METROPOLITAN GOVERNMENT OF NASHVILLE AND DAVIDSON COUNTY

STAFF RECOMMENDATION

216 Fairfax Avenue
September 17, 2014

Application: New construction – addition and outbuilding
District: Hillsboro-West End Neighborhood Conservation Zoning Overlay
Council District: 18
Map and Parcel Number: 10406009000
Applicant: Kevin Mitchell, Designer
Project Lead: Sean Alexander, sean.alexander@nashville.gov

5 ELEVATION - new garage facing back of house
 SCALE: 1/4" = 1'-0"

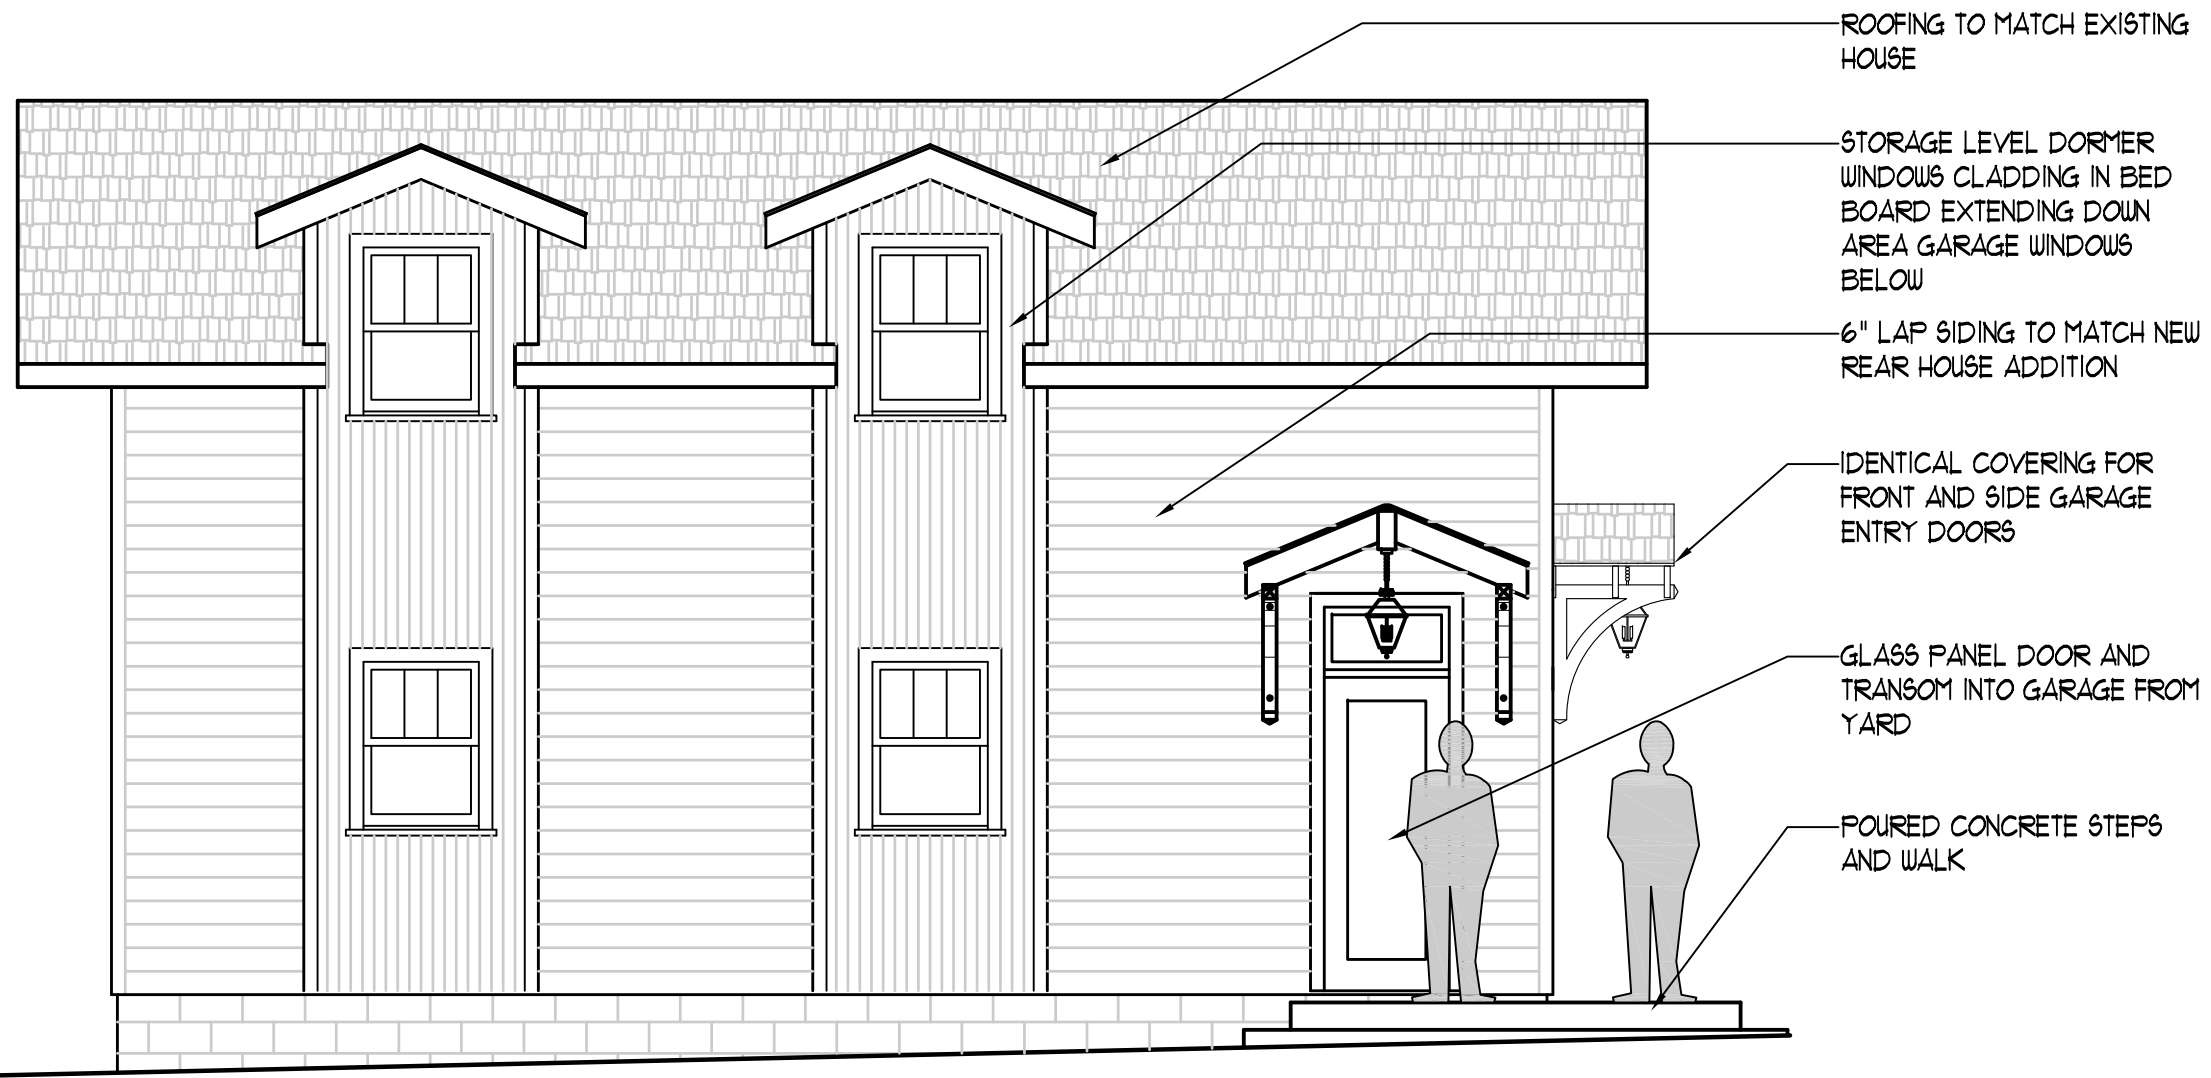
The new outbuilding will have two floors, with a two-car garage on the first story and a bonus/storage area above. The roof peak will be eighteen feet, nine inches (18'-9") above the lower floor level. Because the lot slopes up toward the rear, the peak of the garage will be three feet, two inches (3'-2") higher than the peak of the house. However, the height of the roof measured from the finished floor level will match the house. In order to achieve a truly subordinate outbuilding, it must be subordinate in all ways: ridge

height, eave height, footprint and square footage. The eave height of the garage will be twelve feet, nine inches (12'-9") above the lower floor level. This is nearly three feet (3') greater than the proportional eave height on the house. Staff finds that the ridge and wall heights are not subordinate because they are equal to or greater than the comparable proportions of the house. In the past, the Commission has placed an emphasis on appropriate eave height since it is such a key factor in assuring that the massing of an outbuilding is perceived to be subordinate to the principal building. With the eaves of the outbuilding lowered to match the eave height of the house, and the ridge height lowered, staff finds that the height and scale of the project meet would meet section II.B.1.a and b. of the design guidelines.

The roof of the outbuilding will be a side-facing gable with a 5:12 pitch, matching the pitch of the house's roof. Both the front and rear elevations will have a pair of gabled wall-dormers. Wall dormers are not a typical historic feature but have been allowed on minimally visible garages; however, in this case, they only help to accentuate the fact that the ridge and eave heights are too tall. The height of the eaves above the finished floor level would be nearly three feet (3') taller than the same proportion on the house. Staff recommends that the dormers be roof dormers rather than wall dormers to meet section II.B.1.e. The bead-board could be covered under materials but what should be covered in this section is the roof-wall dormers vs. roof dormers.

The location and materials of the proposed outbuilding are appropriate, but Staff finds that the ridge height and wall height of the proposed outbuilding are not subordinate to

- The selections for windows and doors are approved by Staff prior to installation; and
- The eave ridge and eave height of the garage is lowered to be subordinate to the house; and
- The dormers are of a more compatible form (roof dormers within the plane of the roof instead of wall dormers, and/or having a more appropriate siding material used instead of bead-board on the outbuilding).

6 ELEVATION - new garage facing alley
 SCALE: 1/4" = 1'-0"

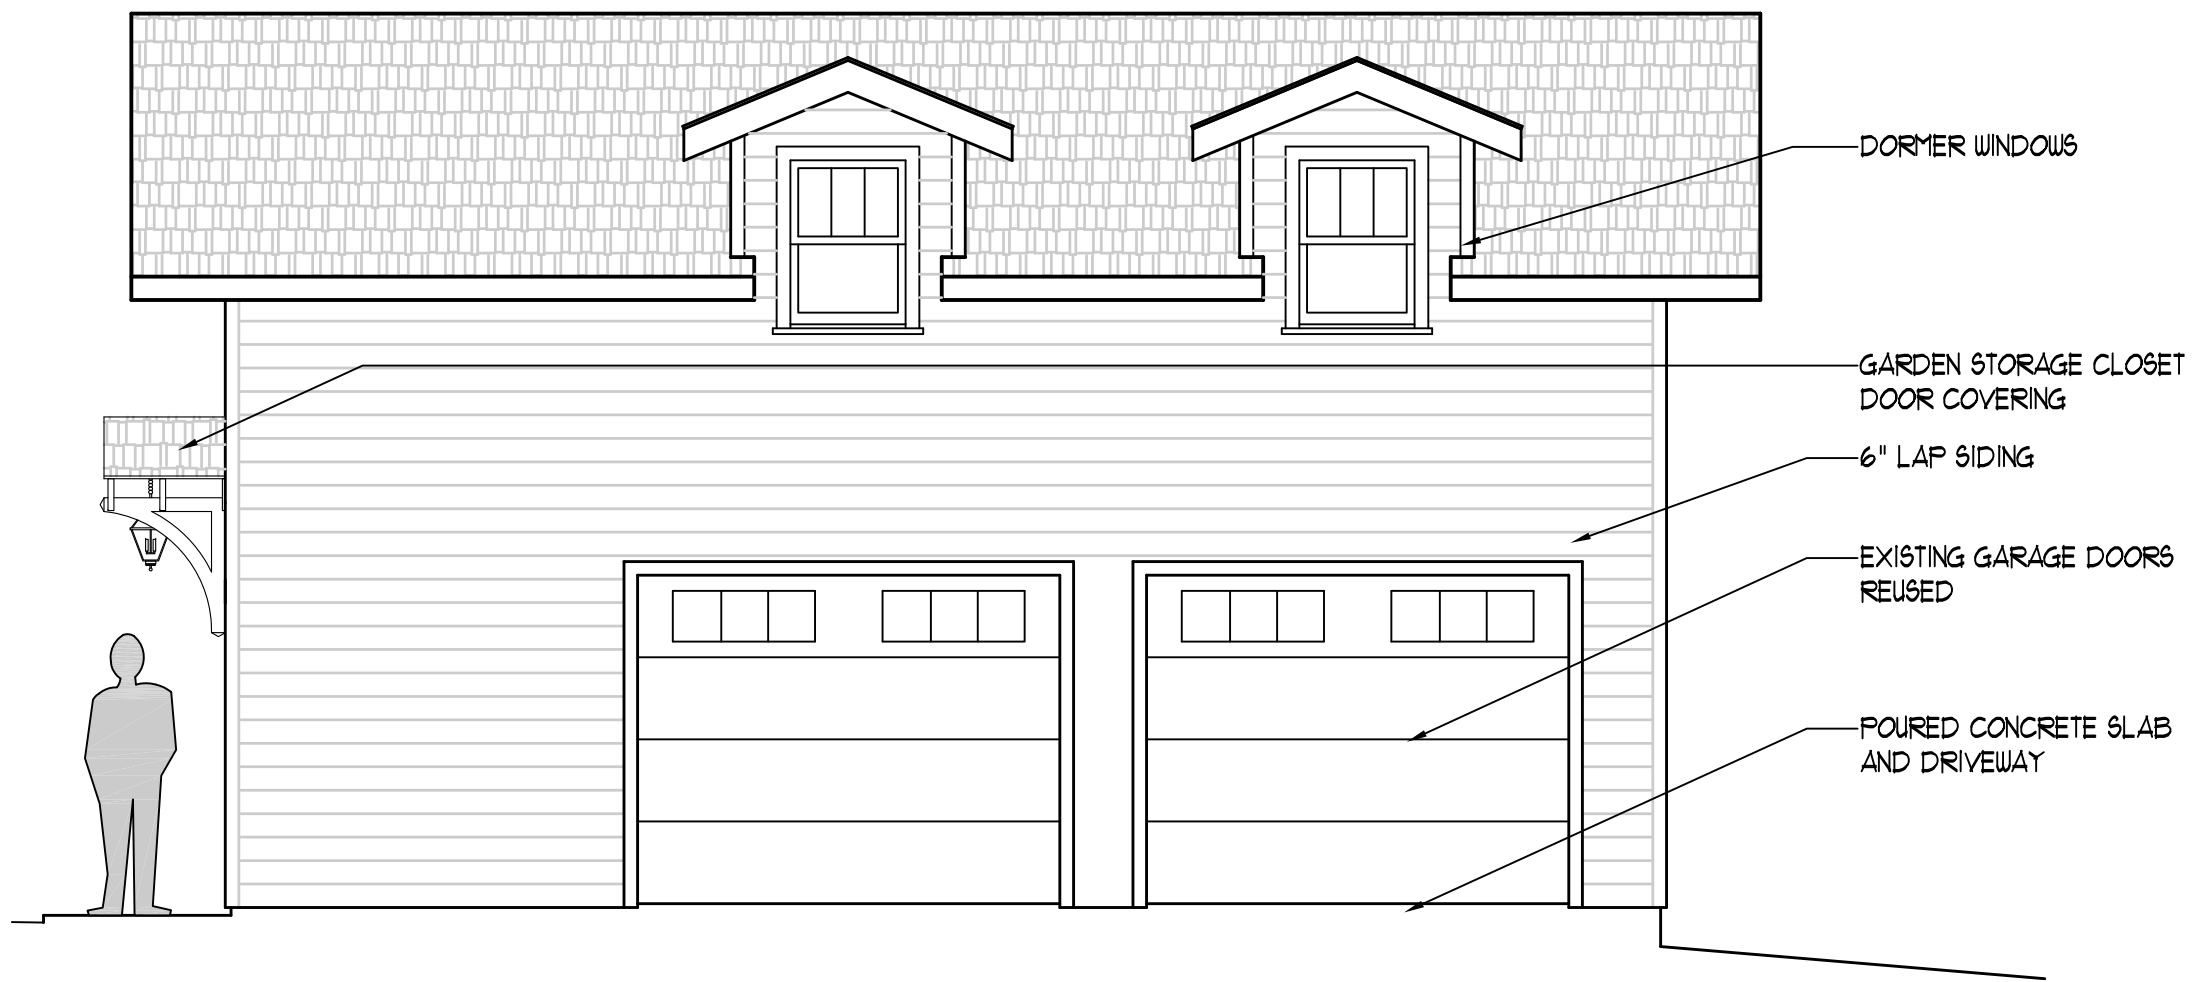
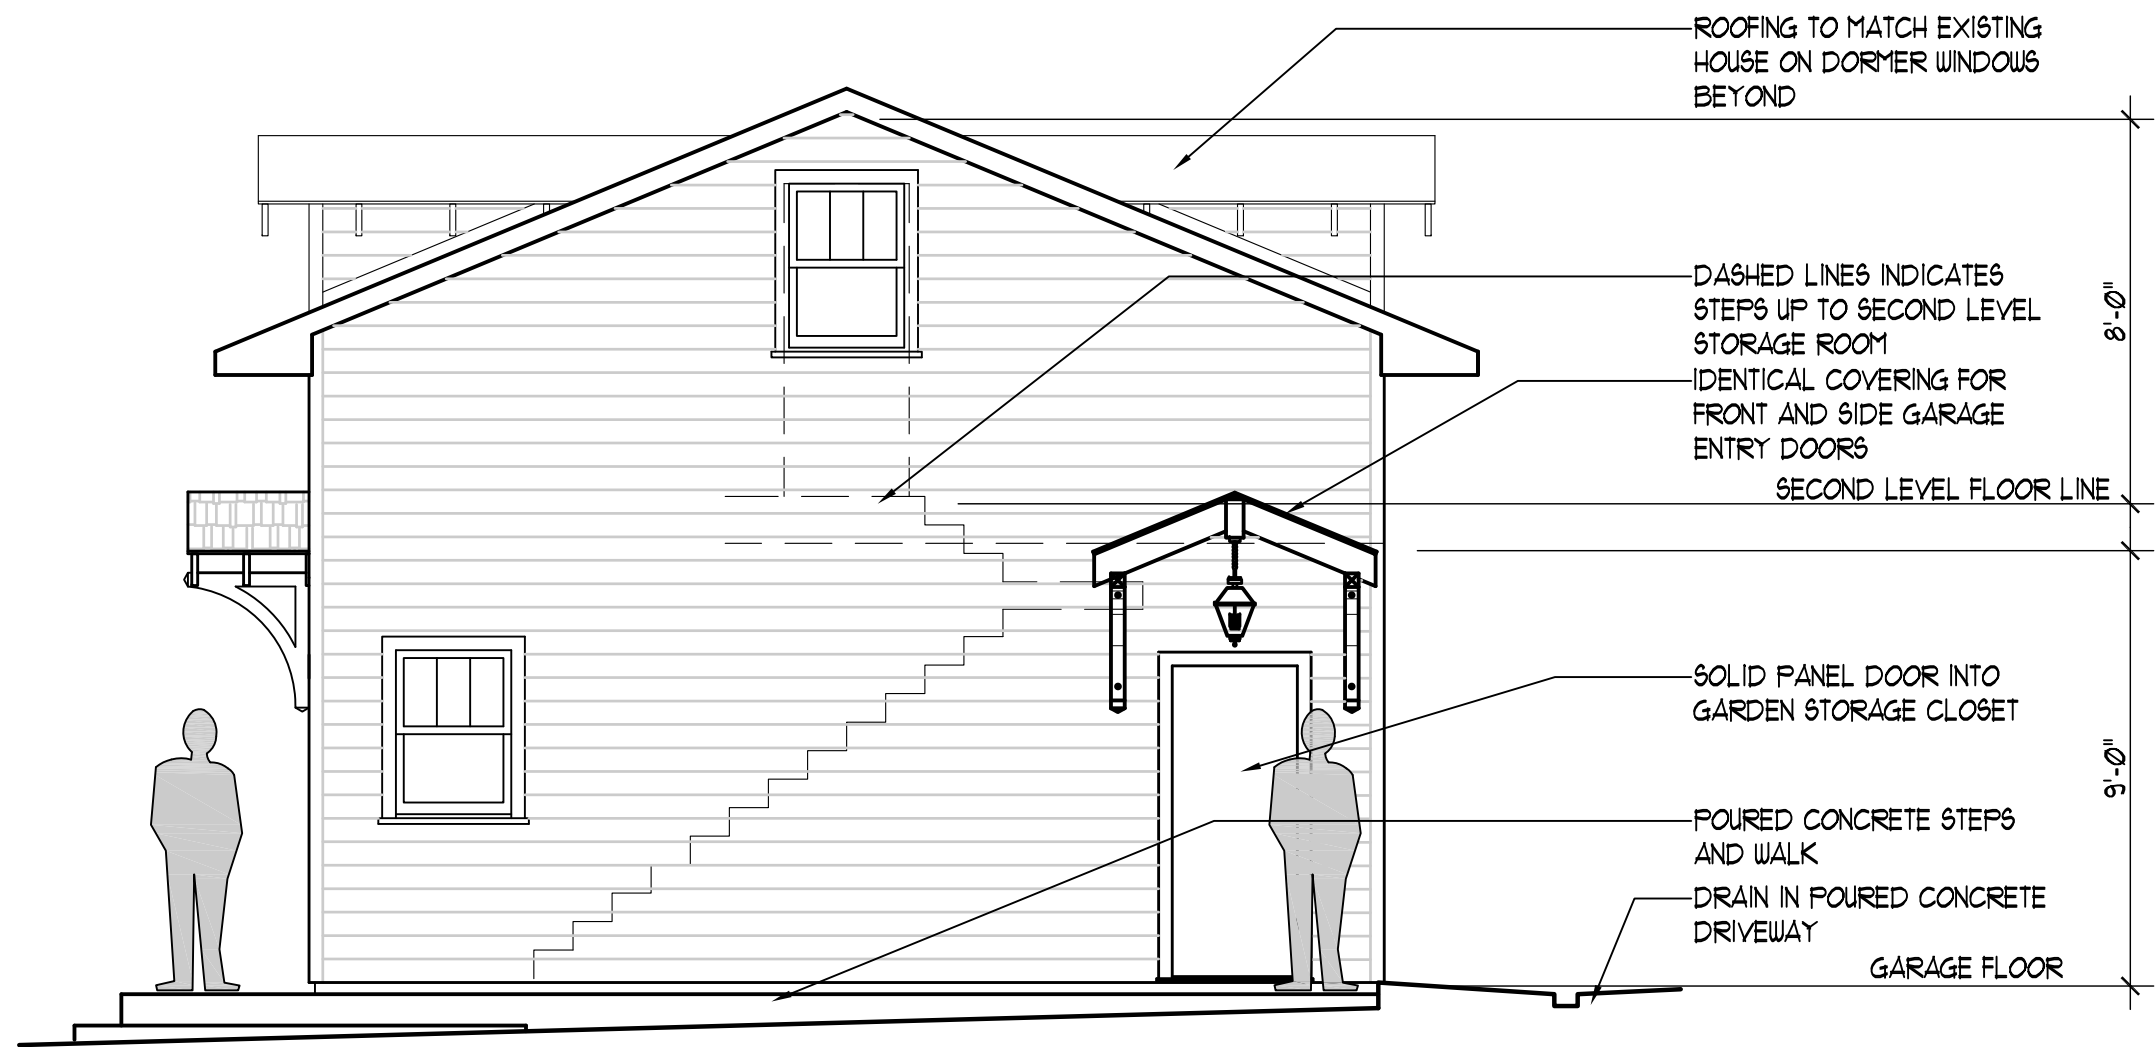
The materials of the outbuilding will match those of the new addition: asphalt-single roof, cement-fiber siding, and a concrete foundation. The trim will be wood. The windows and doors will be wood, and staff asks to approve the final window and door selections prior to purchase and installation. On the front elevation of the building there will be vertically-oriented bead-board panels around the windows, extending the full height of the building. Bead-board is not a typical siding material. Although board and batten or vertical flush-siding is an appropriate material for an outbuilding, staff finds that the attenuated scale of bead-board in this application exaggerates the height of the wall, which is already taller than the walls of the house. With a condition that the a more appropriate siding material is used instead of bead-board accent panels, staff finds that the known materials of the proposal meets section II.B.1.d
